## ITEM 6(d)

**Application Number:** 20/02159/DISCON

**Description** Details submitted pursuant to the discharge of conditions 16 (proposed lighting plan), 18 (car park management plan) and 21 (mural scheme of re-erection) relating to application 18/01469/FUL

**At** 22 - 24 Stantonbury Centre Purbeck Stantonbury

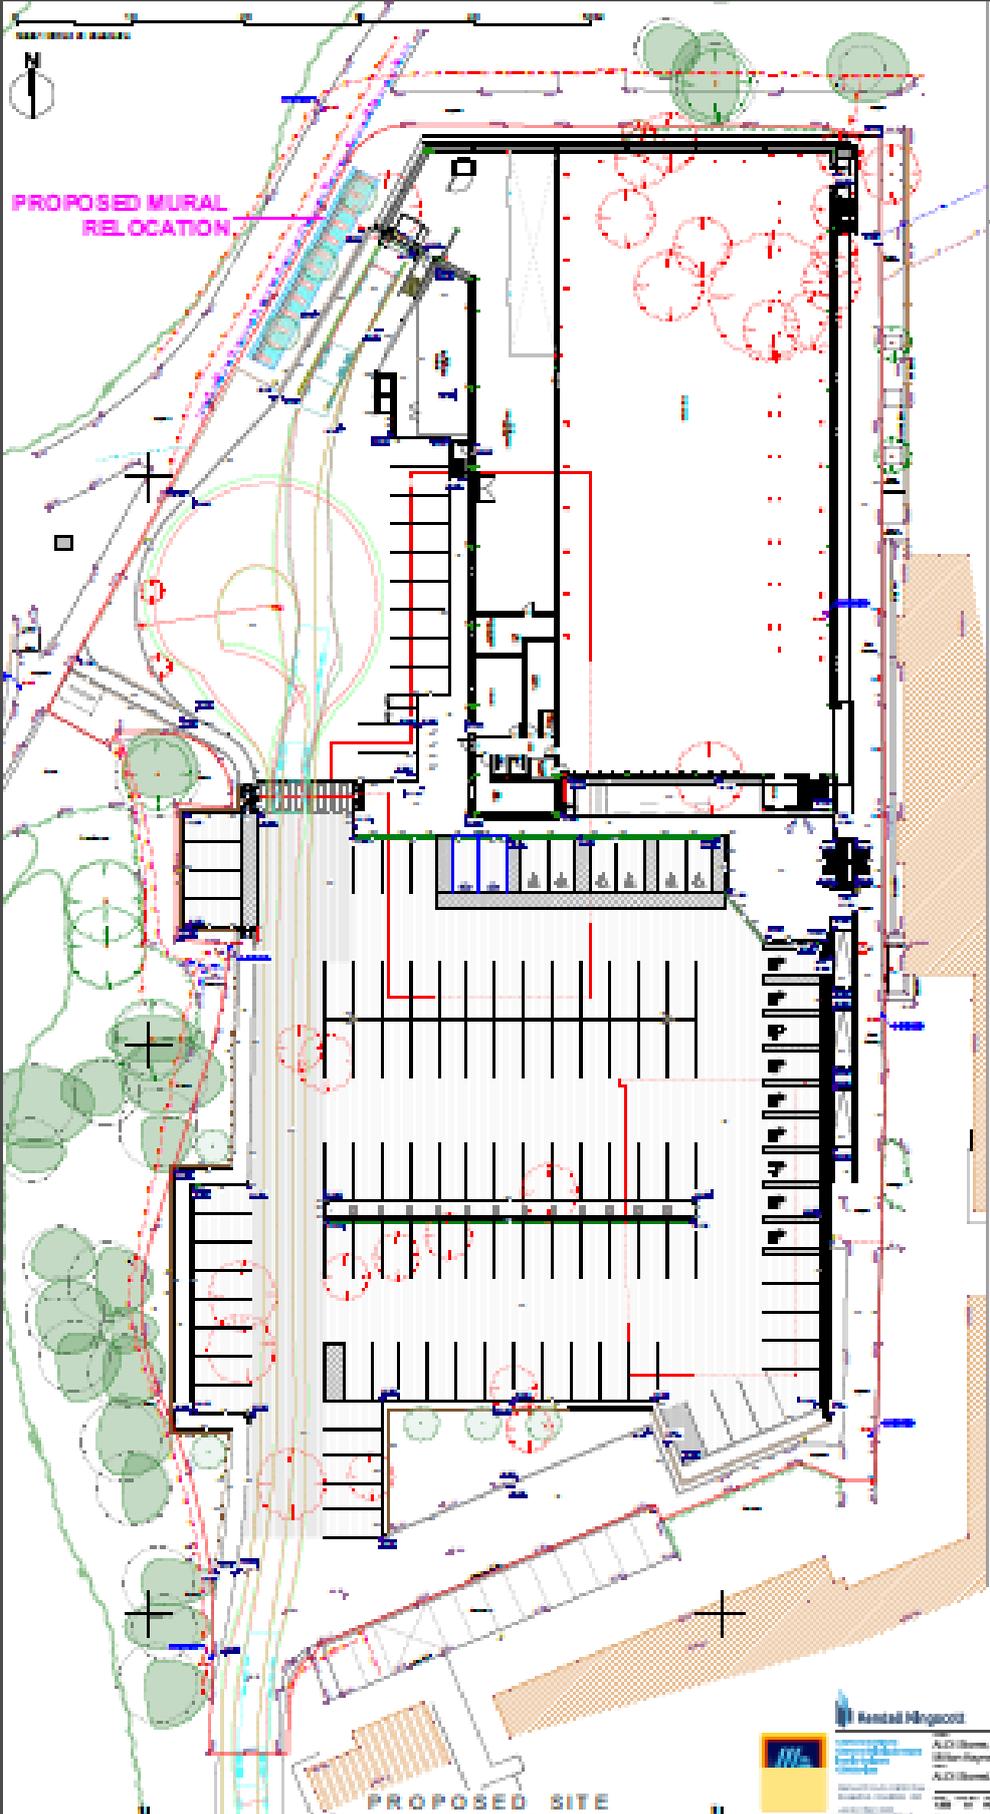
We note the comments from Simon Peart and Louise Izod and note that both have raised the issue of potential vandalism to the mural as shown in the current proposal. We look forward to Aldi's response to this.

We continue to be of the opinion that the proposed location of the mural places it at high risk damage from vandalism and that the application should be rejected.
